PREVOST

**WARRANTY
BULLETIN**

WB17-10A

DATE :	June 2017	SECTION :	26 SLIDE-OUT
EXPIRATION:	June 2019		
SUBJECT :	SLIDE-OUT RAIL BOLT INSPECTION

Figure 3

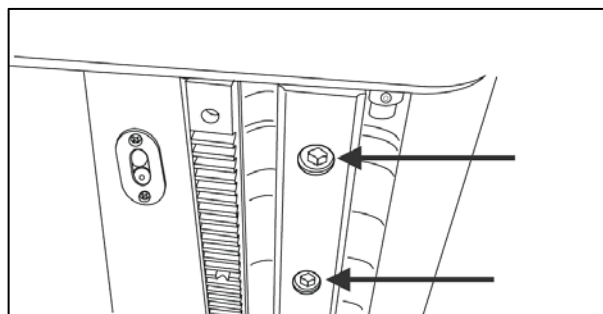
1. Extend the slide-out room.
2. Set the ignition switch to the OFF position and trip the main circuit breakers equipped with a trip button.
3. From under the slide-out, locate the slide out rail socket head screws. (Fig. 3)
4. Remove the protecting cap.

5. Re-torque to **90-100 lb-ft (122-136 Nm)**.

Figure 4

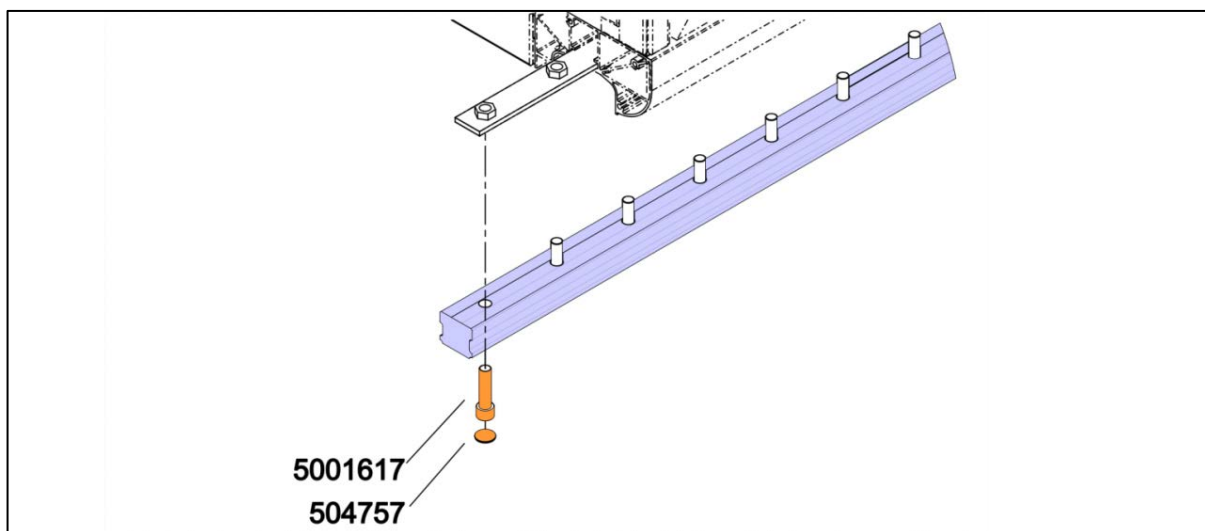
6. If the screw head is broken, use a bolt extractor kit to remove the bolt. Closely follow kit instructions.
7. Replace with a new 5001617 screw (Fig. 4). Tighten to **90-100 lb-ft (122-136 Nm)**.

8. Replace any missing or damaged finishing plugs with replacement plugs #504757 supplied in the kit.(Fig. 4)
9. Finishing plug should be mounted flush with rail surface to avoid inflatable seal damage.
10. Set breakers and ignition switch back on.
11. Confirm proper slide operation.
